**CERTIFICATE OF APPROPRIATENESS**

**Property:** 915 Key St, lot 15, block 220, Norhill Subdivision. The property includes a non-contributing 1,392 square foot, one story wood frame single-family residence and detached garage situated on a (50' x 100') 5,200 square foot lot.

**Proposal:** Alteration – restoration of wood siding, repair of siding and painting, new windows, new front porch, new front and back doors, new roof of composition shingles and new small rear addition.

**Recommendation:** -Denial of COA, Approval of COR with Conditions:

**SOUTH ELEVATION**

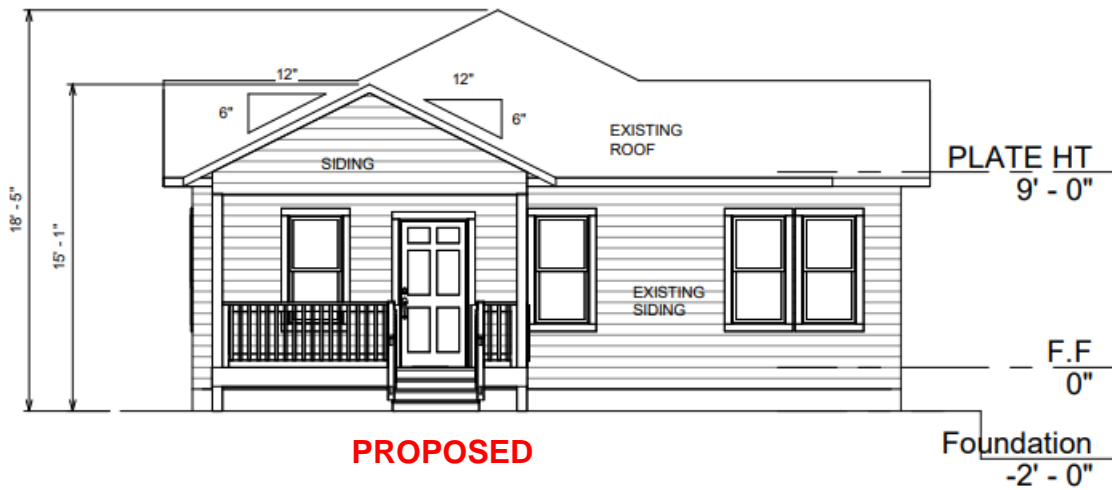
- 1) New front porch: is this porch in line with what was historically there (per the Sanborn maps, old column footing remains, etc)? For the Houston Office of Preservation (HOP) to approve this porch addition, you will need to prove there was a porch there. If you can show evidence of an original front porch, the proposed will need to match that. We would expect to see masonry pillars with tapered columns extending above, as per typical Norhill bungalow front porches.

- 4) Doors: The front door must be approved by NNA and HOP. Suggestion is a typical Craftsman style door. Grogan's has recommended doors that are historically accurate.

**Applicant to work with staff to design an appropriate covered front entrance or modest front porch suited to the context area, expose rafter tails, install inset and recessed appropriate windows, restore and repair siding with similar lap siding. Install appropriate Craftsman style front door.**

EAST ELEVATION

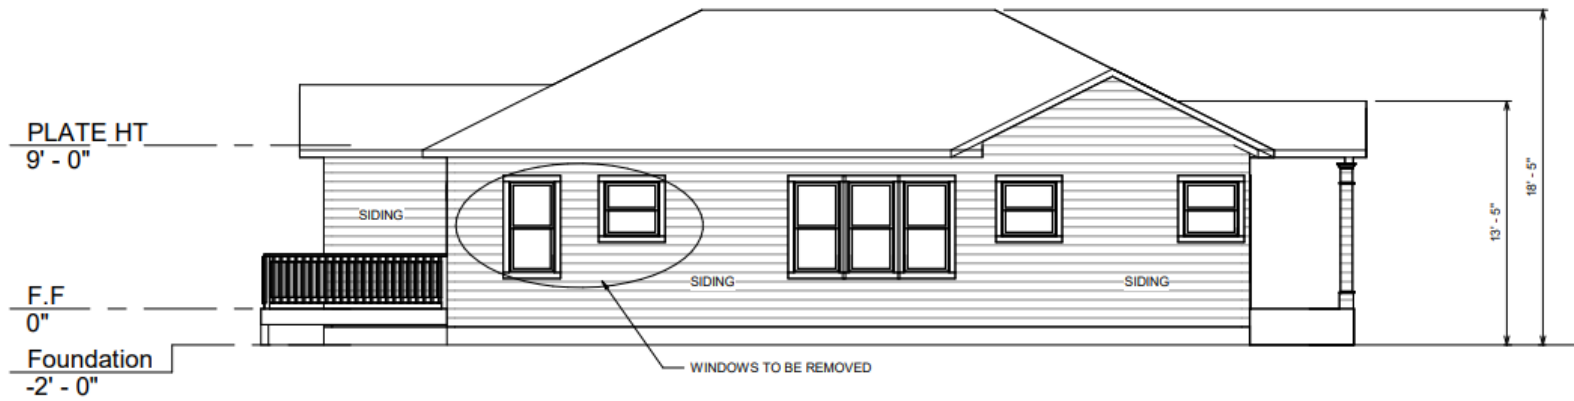
- 2) Windows: HOP will not allow the removal of any original windows. This includes the two small windows on the right side elevation and the two windows toward the rear of the left side elevation. In some cases I believe they will allow an existing full-height window to be reduced in height, especially a window in a bathroom, but this is on a case-by-case basis. Also, the new windows should be wood and inset/recessed and trimmed as per the originals. We didn't see this noted.
